ArevaEPRDCPEm Resource

From: BRYAN Martin (EXTERNAL AREVA) [Martin.Bryan.ext@areva.com]
Sent: Monday, August 23, 2010 4:36 PM
To: Tesfaye, Getachew
Cc: DELANO Karen (AREVA); ROMINE Judy (AREVA); BENNETT Kathy (AREVA); CORNELL Veronica (EXTERNAL AREVA)
Subject: Response to U.S. EPR Design Certification Application RAI No. 320, FSAR Ch 3, Supplement 2, Part 1 of 2
Attachments: RAI 320 Supplement 2 Response US EPR DC (Part 1 of 2) - INTERIM.pdf

The attached file, "RAI 320 Supplement 2 US EPR DC (Part 1 of 2) – INTERIM.pdf" and the file "RAI 320 Supplement 2 US EPR DC (Part 2 of 2) – INTERIM.pdf" in subsequent email, provide technically correct and complete INTERIM responses to Question 03.07.02-63 and Question 03.07.03-37, as committed.

RAI 320,
Question
03.07.02-63

Figure 5.0-1—Design Response Spectra for EUR Control Motions (Hard, Medium and Soft Sites)

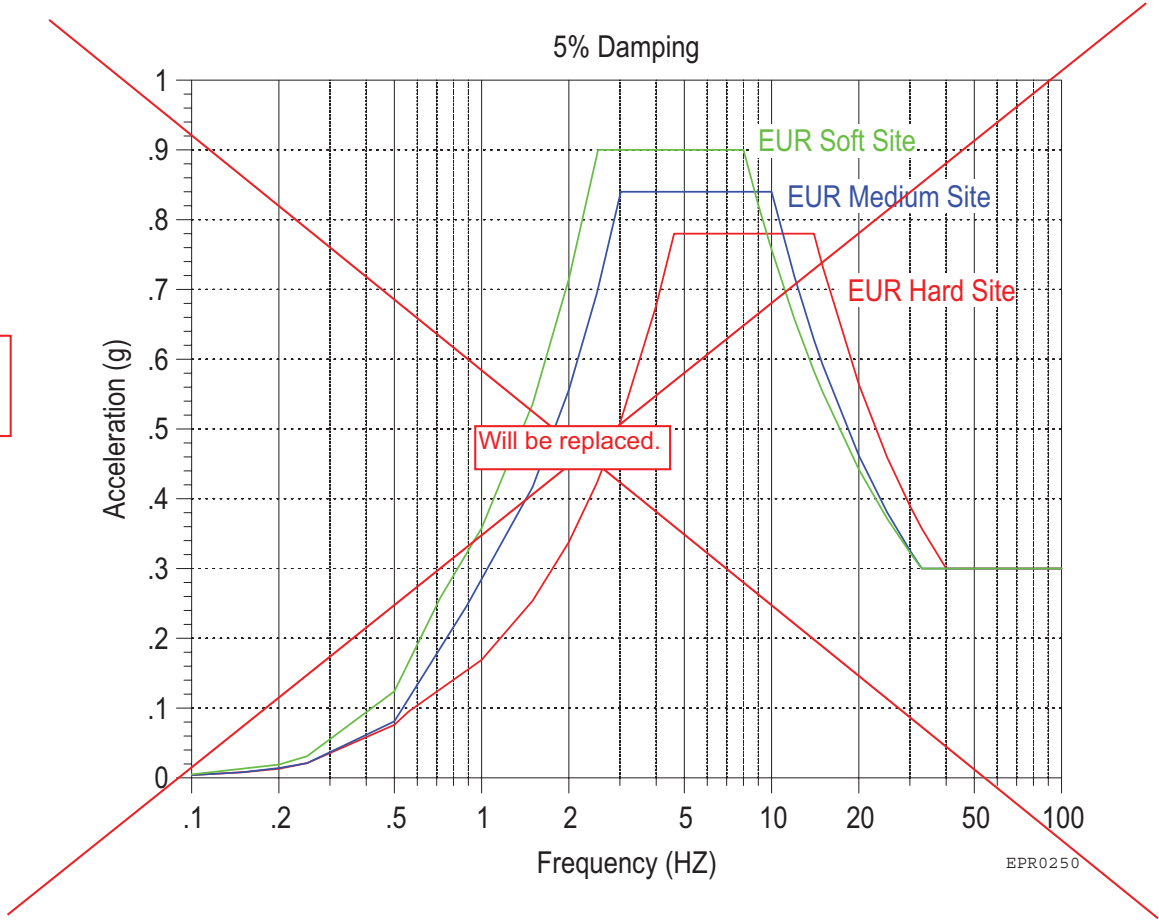
- U.S. EPR FSAR Tier 1, Table 5.0-1 will be revised to specify the peak ground accelerations for the high frequency input motion.
- U.S. EPR FSAR Tier 1, Figure 5.0-1 will be revised to include the spectra for the high frequency input motion.

U.S. EPR FSAR Tier 1, Table 5.0-1 and Figure 5.0-1 and U.S. EPR FSAR Tier 2, Table 2.1-1, Section 2.5.2, Section 3.7.1, Section 3.7.2, and Section 3.8.5 will be revised as described in the response and indicated in the enclosed markup.

Figure 3.7.1-2—Comparison of CSDRS to RG 1.60 and the Minimum Required Spectrum, Horizontal Motion

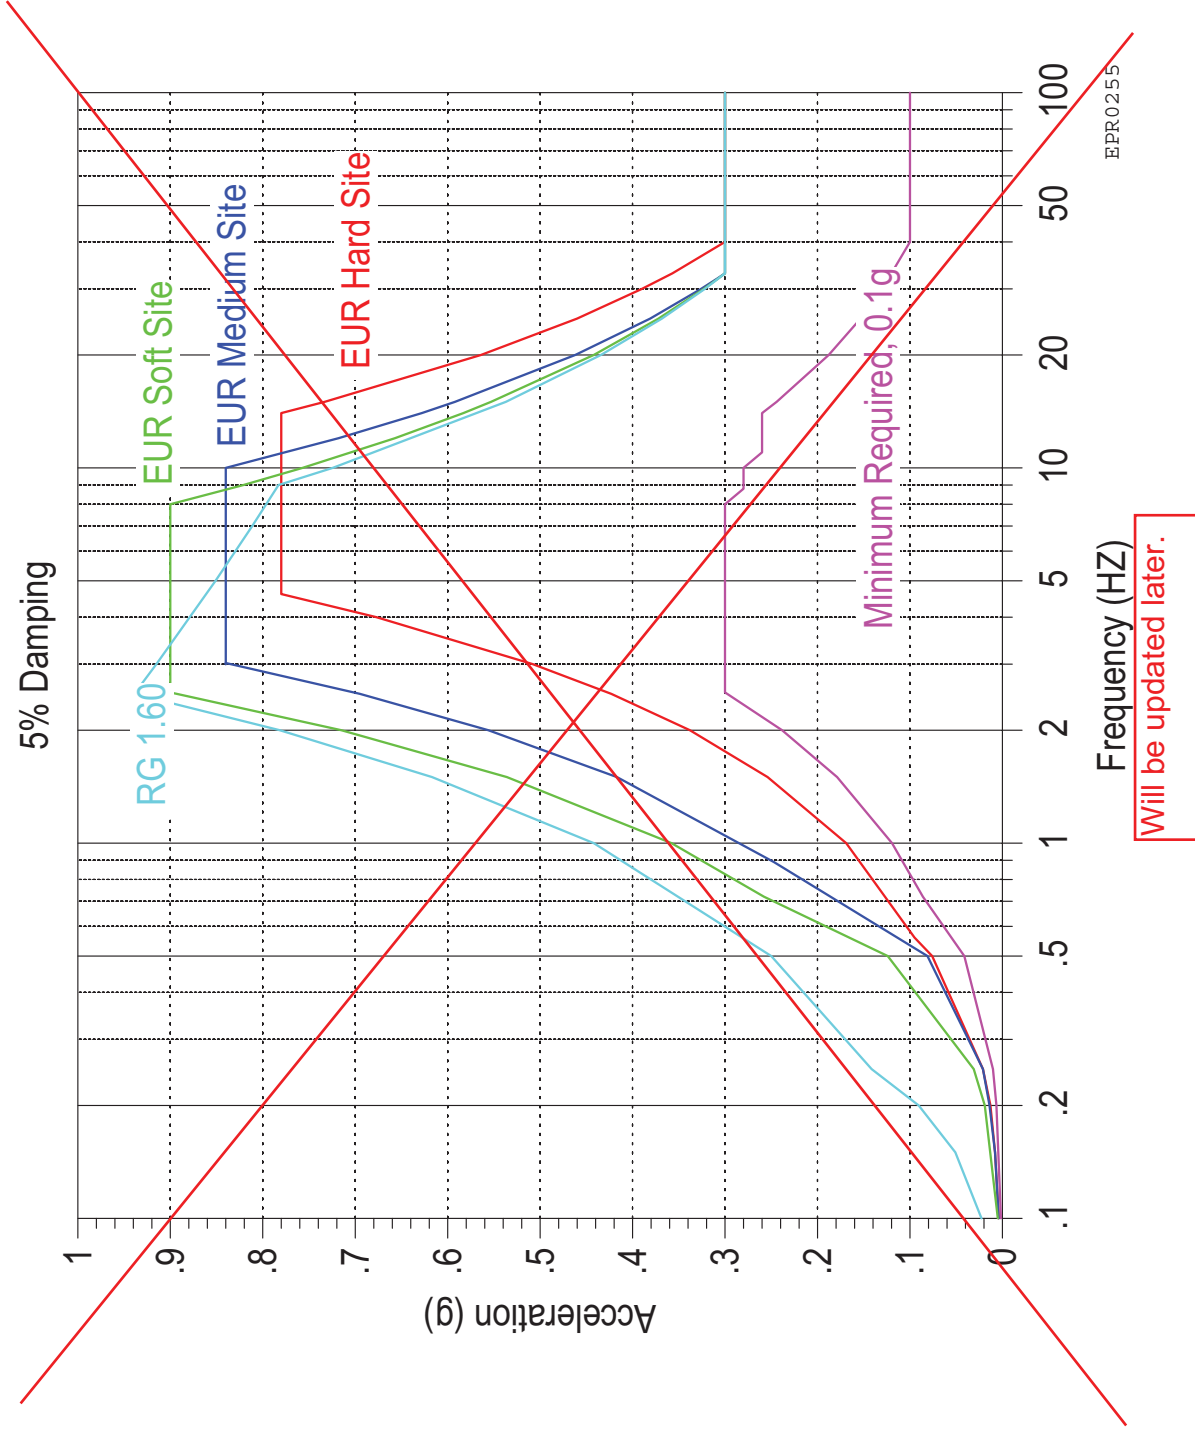
Figure 3.7.1-2—Comparison of CSDRS to RG 1.60 and the Minimum Required Spectrum, Horizontal Motion, ~~Horizontal Motion~~, and Figure 3.7.1-3—Comparison of CSDRS to RG 1.60, Vertical Motion, compare the EUR control motions to the design ground motion from RG 1.60 and to the 0.1g minimum horizontal design ground motion. The EUR control motions provide an enhanced high frequency range when compared to RG 1.60 spectra. For horizontal motion, the RG 1.60 horizontal spectrum exceeds the EUR spectra below about 3 Hz. For vertical motion, the EUR spectra ~~exceed RG 1.60 vertical spectrum~~ except in the frequency range below approximately

Figure 3.7.1-29—~~Idealized Control Motion for Seismic Input to NI Common Basemat~~ ← Deleted

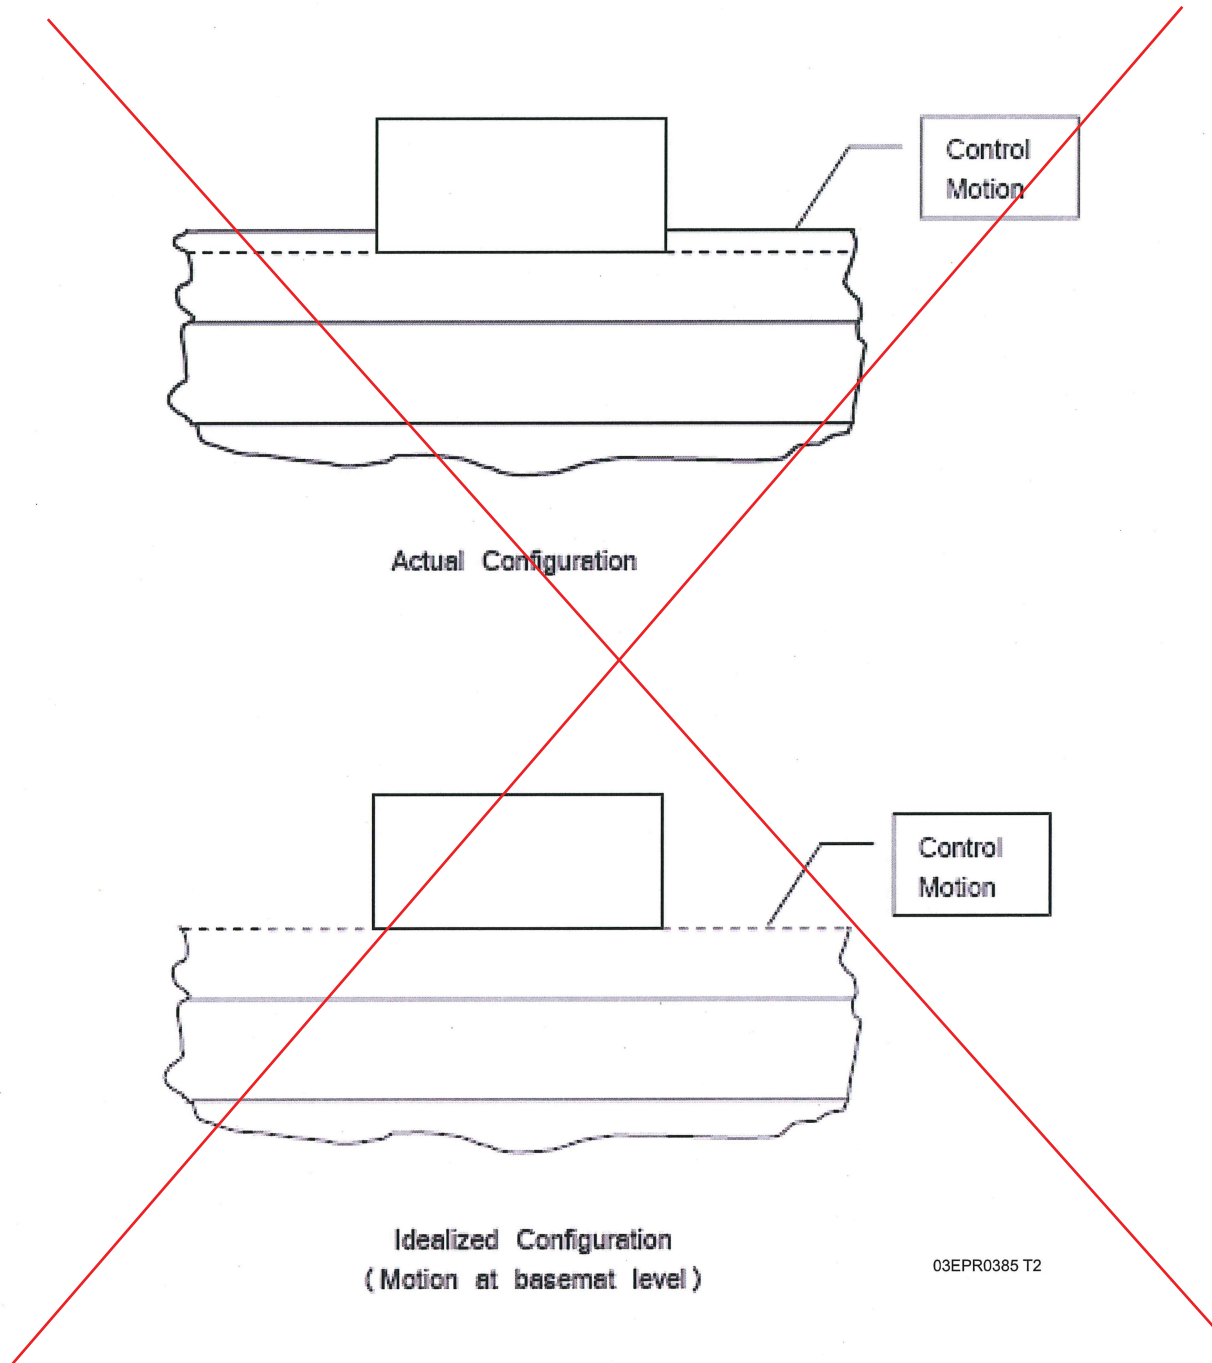
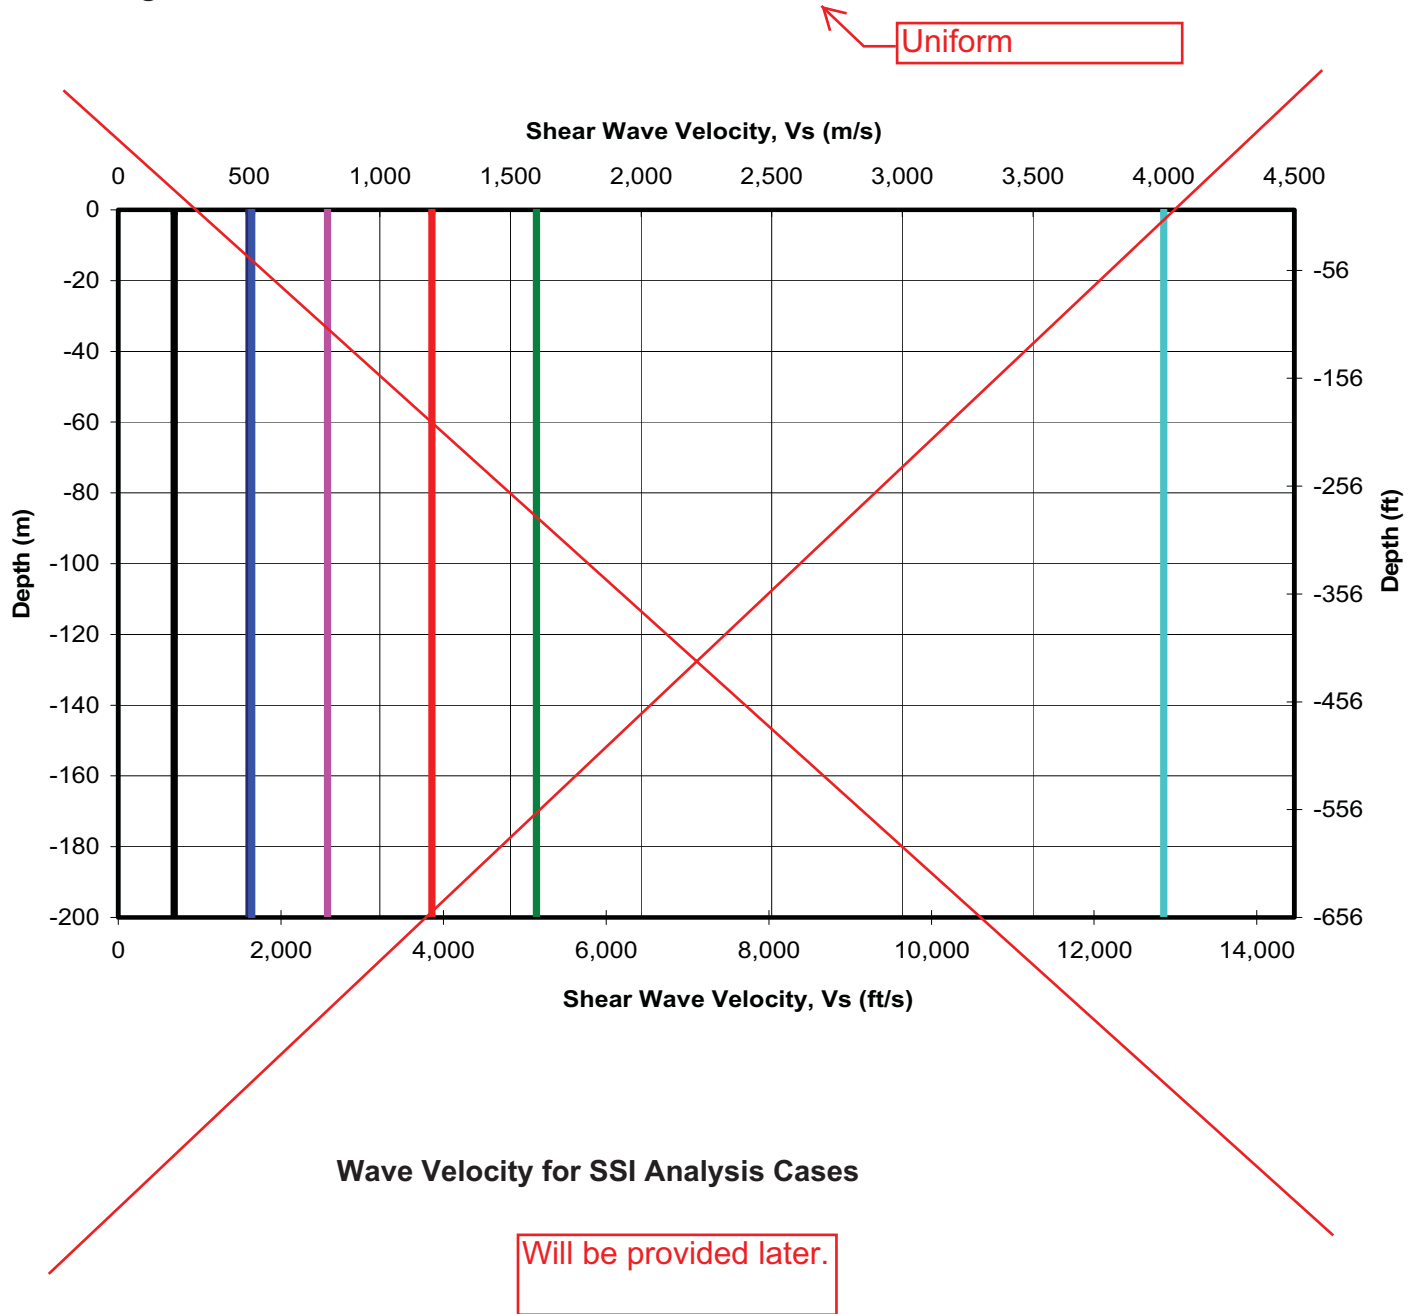
Figure 3.7.1-30—Figure Deleted
